MICHIGAN DEPARTMENT OF ENVIRONMENTAL QUALITY

DATE: June 19, 2008

SUBJECT: Pall Life Sciences, Scio Township, Washtenaw County  
Review of Evergreen System Capture Effectiveness

Figure 1 – 1,4-Dioxane concentrations at LB wells.

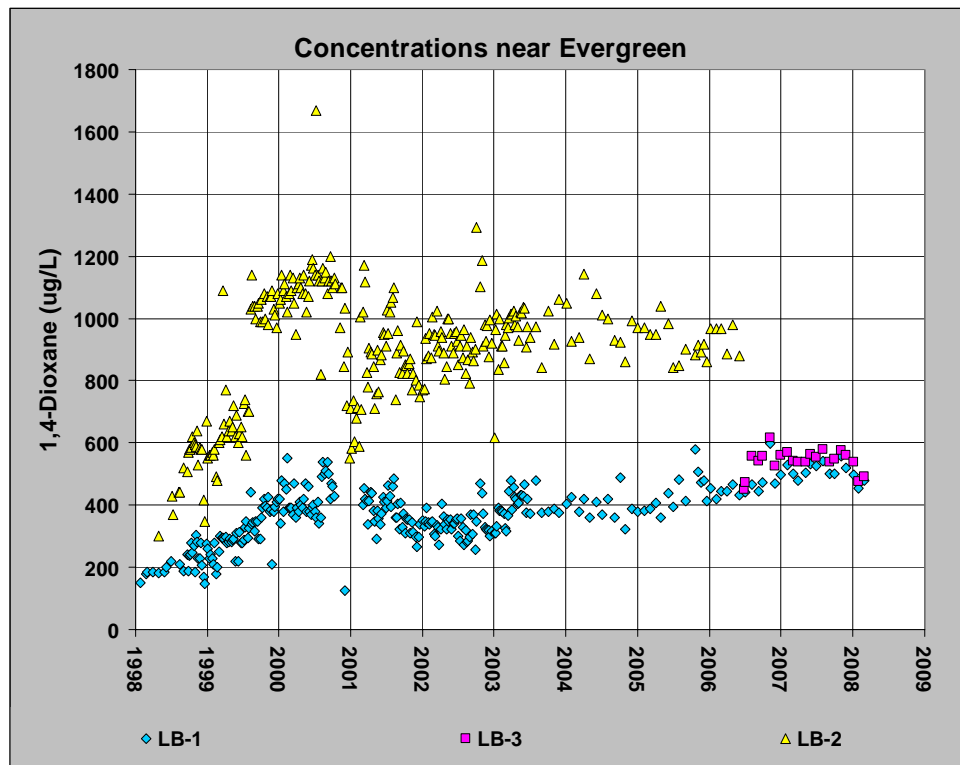
The 1,4-Dioxane concentration data from monitoring wells in the vicinity of, and including, LB-1, LB-2, and LB-3 were graphed and examined for temporal trends to determine whether the extraction wells have contained the contaminant plume, resulting in declining 1,4-Dioxane concentrations. The graphs of these data are shown in Figures 1 through 5 attached to this memorandum. Figure 1 shows the 1,4-Dioxane concentrations at the three LB extraction wells. From this figure, it should be apparent that these wells have removed 1,4-Dioxane contaminated groundwater from the aquifer, and that the concentrations of groundwater extracted by well LB-2 were considerably and consistently higher than either LB-1 or LB-3. Figure 2 shows the mass of 1,4-Dioxane removed per gallon of groundwater extracted (units are pounds per gallon). Since the pumping rates for each well were similar, the obvious conclusion is that the screened interval in well LB-2 was located closer to higher 1,4-Dioxane concentrations than the screens in either wells LB-1 or LB-3, and that well LB-2 was much more effective in removing 1,4-Dioxane from the aquifer than its replacement, LB-3.

Figure 3 – 1,4-Dioxane Concentrations at 2819 Dexter.

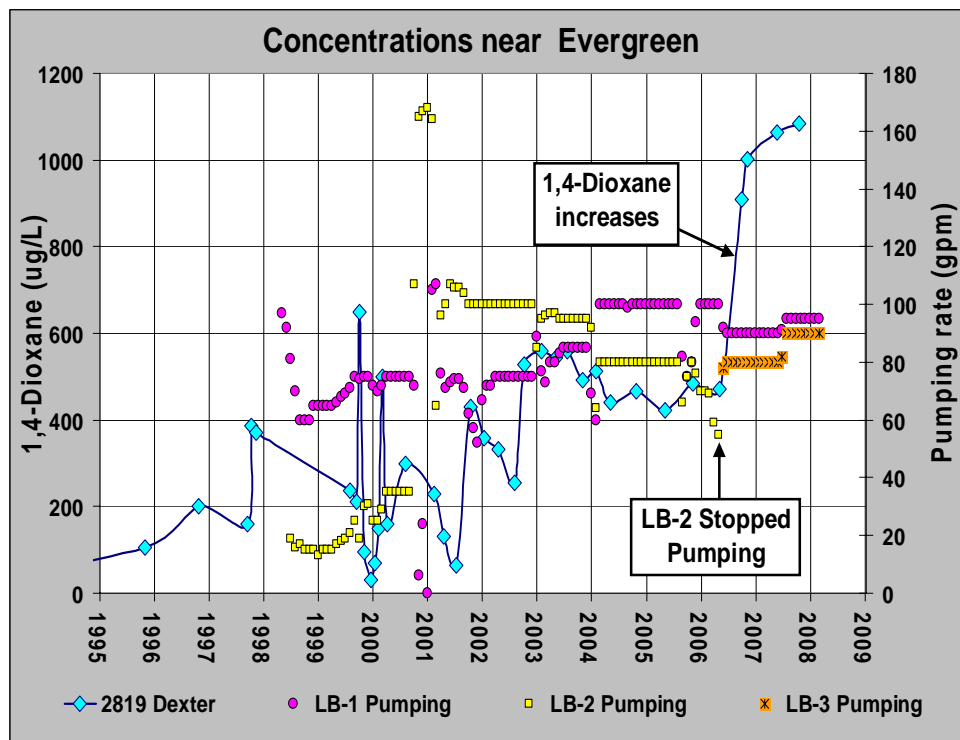
Figures 3, 4, and 5 show 1,4-Dioxane concentrations at wells 2819 Dexter, 2805 Dexter, and MW-BE-1s, respectively. Also shown on these graphs are the pumping rates for LB-1, LB-2, and LB-3 (pumping rate on right-hand y-axes). From the plot of the extraction-well pumping rates, the time at which well LB-2 stopped pumping can be determined. As pumping rates in this well decreased and eventually stopped, the 1,4-Dioxane concentrations in nearby and downgradient monitoring wells increased, even though the replacement well, LB-3, pumps at a similar rate as LB-2. Keeping in mind that LB-3 is located to the north, it's our opinion, based on an examination of the existing dataset, that the greatest 1,4-Dioxane concentrations are probably located at LB-2 or to the south of LB-2. Turning off LB-2 appears to have allowed higher contaminant concentrations to move toward the well at 2819 Dexter Road and past Evergreen Street toward the wells at 2805 Dexter Road and MW-BE-1s. Lacking hydraulic-head data, it is not entirely clear whether or not the well at 2805 Dexter Road is within the extent of capture of the LB wells; however, since the increase in 1,4-Dioxane concentrations seen at

the wells at 2819 and 2805 Dexter Road is observed at MW-BE-1s, we believe that this portion of the contaminant plume is not contained by the combined pumping by LB-1 and LB-3. We also do not believe that the contamination detected at MW-BE-1s can be contained by pumping the existing LB wells.

Figure 6 – 1,4-Dioxane Concentrations at 440 Clarendon and 456 Clarendon.

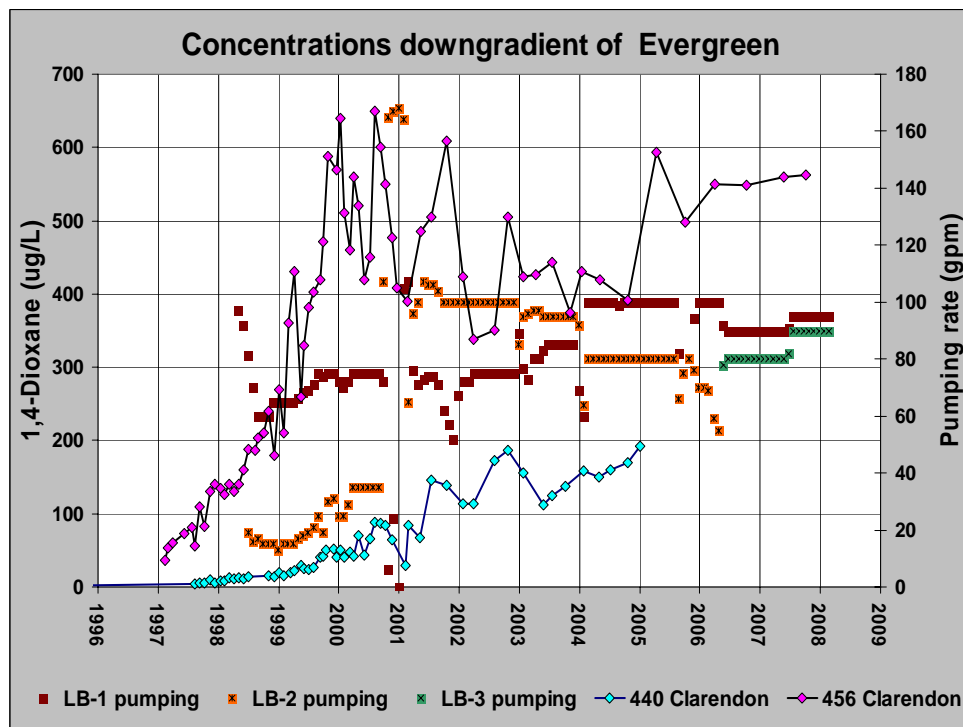
Figure 6 shows the 1,4-Dioxane concentrations at the wells at 440 Clarendon and 456 Clarendon, along with pumping rate for the LB wells. Groundwater samples have been collected at 456 Clarendon since 1997 through the present, while sampling from the well at 440 Clarendon was stopped at the end of 2004. Data on this graph shows that concentrations of 1,4-Dioxane at 440 Clarendon and 456 Clarendon have continued to increase since 1997. Pumping from LB-1 and/or LB-2 may have had an impact on stabilizing 1,4-Dioxane concentrations at 456 Clarendon (see graph between 2001 and 2005). We believe that the increase in concentrations from 2005 to the present at 456 Clarendon may be attributed to a reduction in pumping at LB-2 and shifting the pumping to LB-3, or simply a movement of contaminants from the west and south of the LB-series wells.

Figure 7 – 1-4-Dioxane Concentrations between Evergreen and Allison.

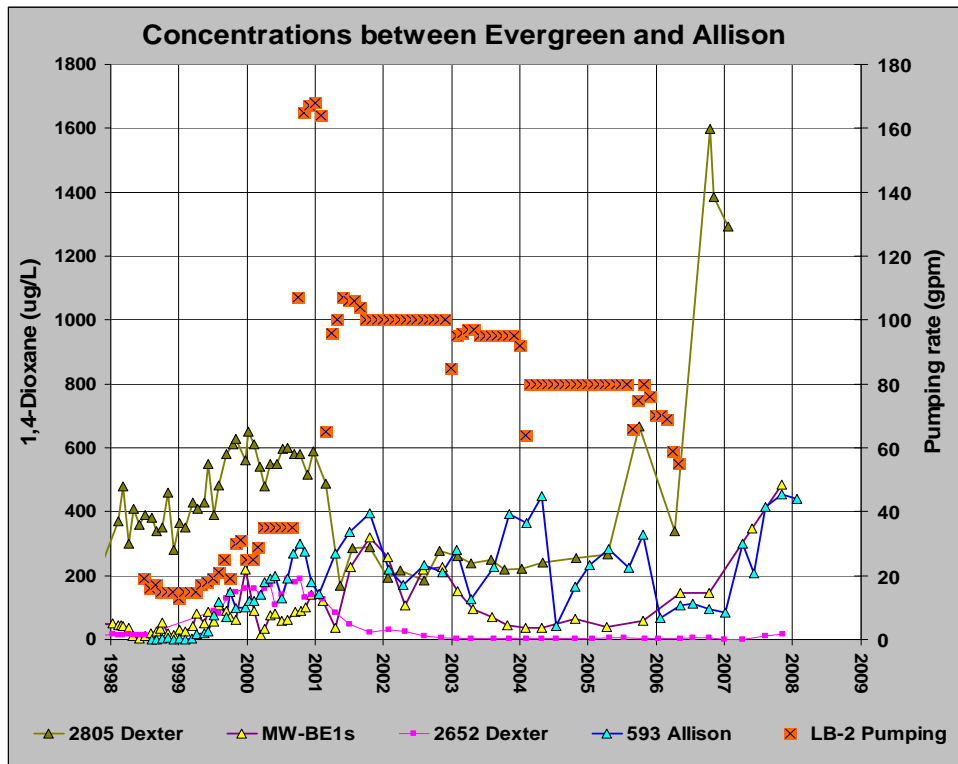
Figure 7 shows 1,4-Dioxane concentrations in sampled wells between Evergreen and Allison and the pumping rate for well LB-2. After well LB-2 was shut-down, the 1,4-Dioxane concentrations in wells at 2805 Dexter, MW-BE-1s, and 593 Allison increased. It appears that the change in the LB-series well system has resulted in a release of higher concentration 1,4-Dioxane that has migrated to Allison Street.

Figure 8 – Mass 1,4-Dioxane removed per gallon pumped.

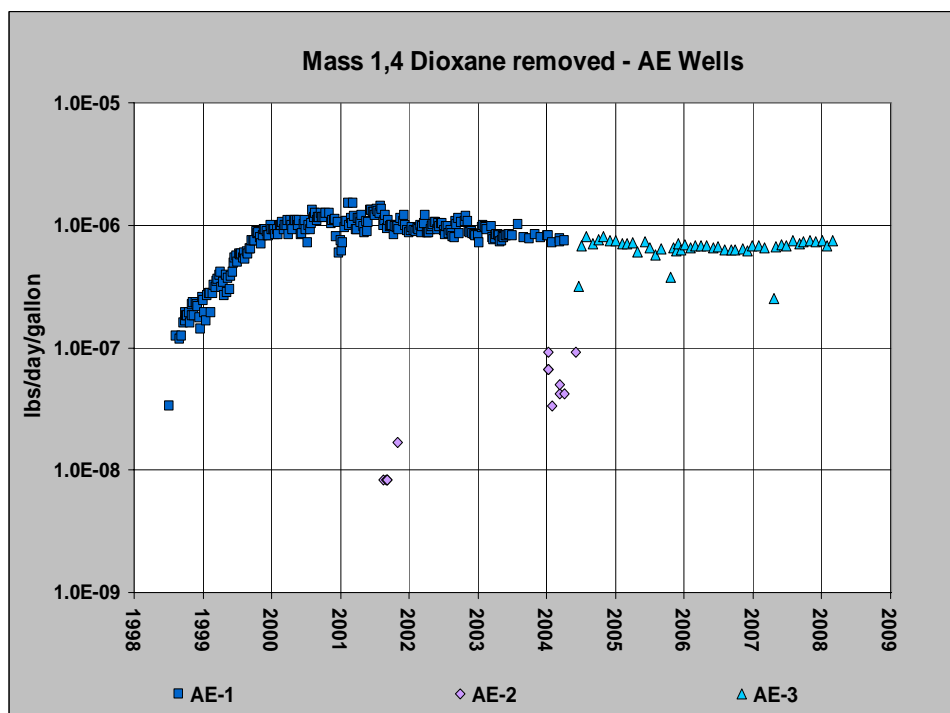
The mass of 1,4-Dioxane removed per gallon extracted from the Allison-series wells is shown in Figure 8. The mass removal rate, while low, had been fairly consistent until mid-2003 when removal rates started declining. Throughout 2006, the removal rate remained fairly consistent

Figure 9 – 1,4-Dioxane Concentrations at AE-1, AE-2, and AE-3.

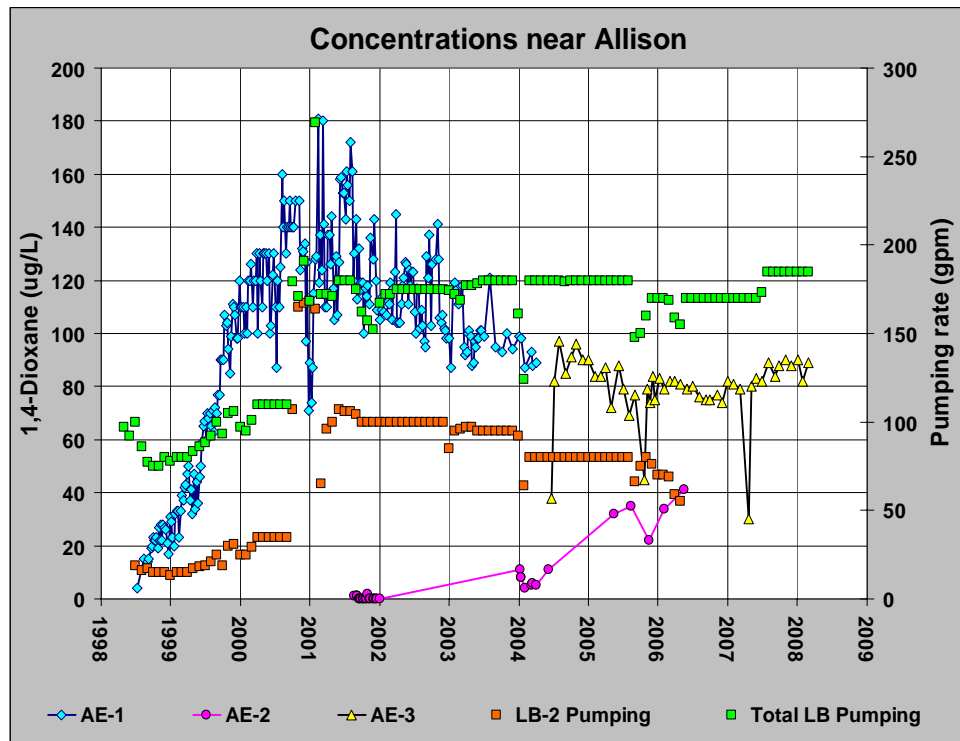
and then started increasing in 2007. The concentrations of 1,4-Dioxane in the AE-series wells and the pumping rates at LB-2 and total LB-series pumping are shown in Figure 9. There has been an increase in 1,4-Dioxane concentrations at AE-3 since early 2007, and there had been a continuous increase in 1,4-Dioxane at AE-2 until sampling stopped in 2006. It's our opinion that the increase in mass removal rates and 1,4-Dioxane concentrations is the result of a partial loss of containment by the LB-series wells.

Figure 10 – 1,4-Dioxane Concentrations at Allison Street residential wells.

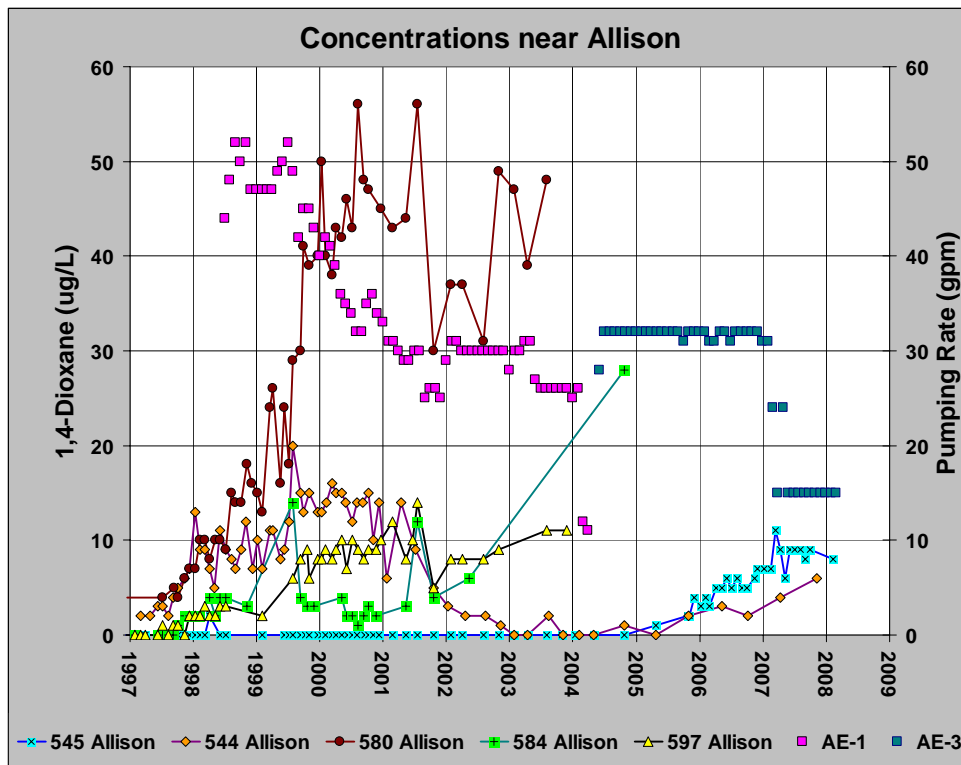
Figure 10 shows the 1,4-Dioxane concentrations in Allison Street residential wells. As shown in this figure, except for the residential wells at 544, 545, and 593 (shown in Figure 7) Allison, all other previously sampled wells have been dropped from the sampling network. There had been a steady increase in concentrations in wells at 580, 584, and 597 Allison between early 1997 and late 2003 or 2004 when sampling each of these wells stopped. The reason for this increase is not known. The 1,4-Dioxane concentrations at 544 Allison decreased between 2001 and 2003. However, since early 2005, the 1,4-Dioxane concentrations in the wells at 544 and 545 Allison have increased steadily. This increase appears to be the result of higher 1,4-Dioxane concentrations migrating past the LB-series wells toward Allison Street.

Figure 11 – 1,4-Dioxane Concentrations downgradient of Allison.

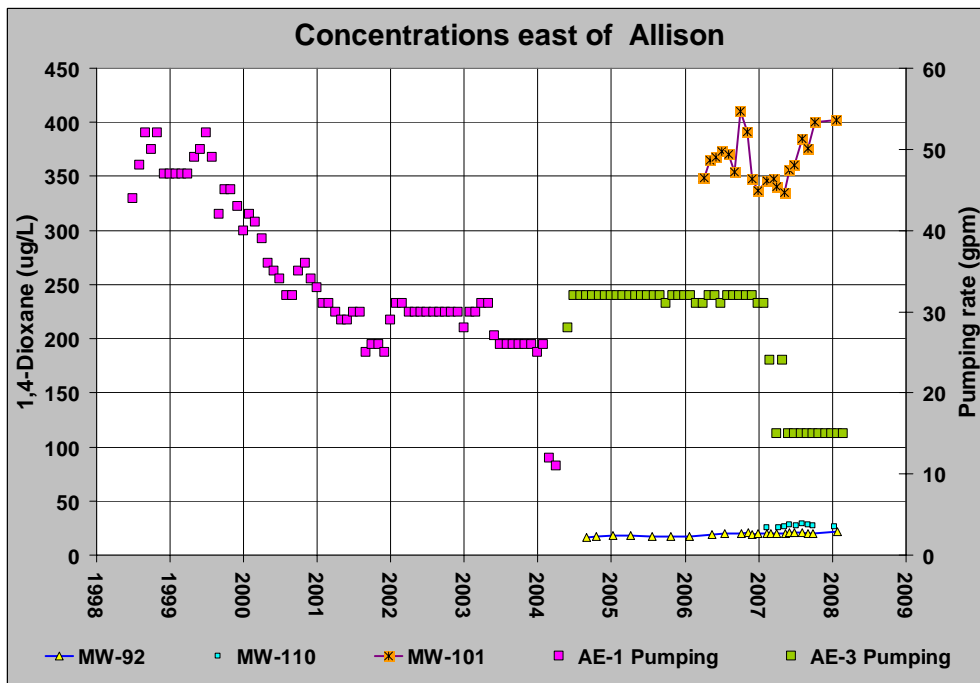
Figure 11 shows the 1,4-Dioxane concentrations in wells downgradient of Allison Street that were installed using vertical aquifer sampling, these are MW-92, MW-101, and MW-110. The concentrations in wells MW-101 and MW-110 have shown an increase since 2007. There has not been a similar increase observed at well MW-92. Wells MW-101 and MW-110 are located in a downgradient direction from extraction well AE-3. The increase in 1,4-Dioxane concentrations in these wells may be related to the increased 1,4-Dioxane concentrations migrating toward Allison Street from Evergreen and a decrease in pumping rates at AE-3 from approximately 30 gpm to 15 gpm. Only the concentrations at MW-101 exceed 85 ug/L.
